**Government of India
Ministry of Railways
Research Design & Standard Organisation
Manak Nagar, Lucknow – 226 011.**

Modification Sheet No. ELRS/ MS /0327

1.0 Title: LED indication on driver's desk to indicate tripping of Static Converter.

REF. NO.	PART NO.	DESCRIPTION	NO/ LOCO	MATL.	LOCO
REF.		SCALE : NTS	APPD. BY:-	FOR DG	
LED INDICATION FOR TRIP STATUS OF STATIC CONVERTER			FIRST ISSUED JULY 2003		
			SUPERSEDS		
RDSO ELECT. DTE.			SKEL- 4674		
SUPERSEDED BY

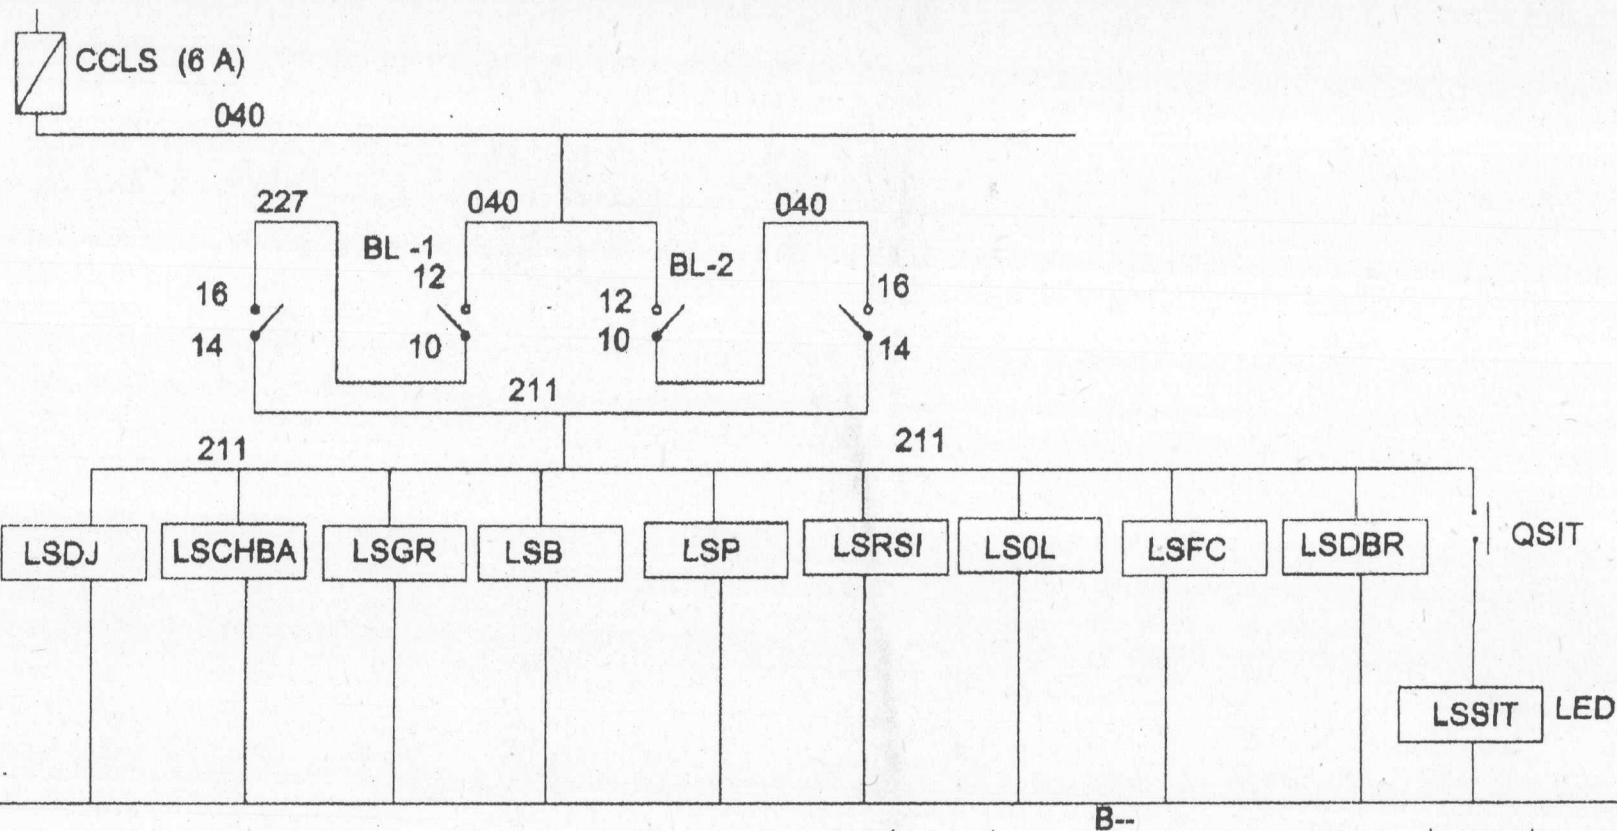
3.1 CLW has already cut in provision of 10-lamp signalling lamp box to CLW Drawing No.- CLW/ES/SK-2/L-24 since 2001-02 in place of earlier 8-lamp signalling lamp box. If this is provided, one number of LED lamp of Amber colour is available and be used and designated as LSSIT. If this is not provided, existing 8 lamp signalling lamp box be replaced with 10 lamp signalling lamp box.

3.2 QSIT relay has been provided in the locomotive with 04 NC and 04 NO contacts. One NO contact of this relay is to be used in series with supply to LSSIT as shown in enclosed RDSO Drawing No.SKEL-4674.
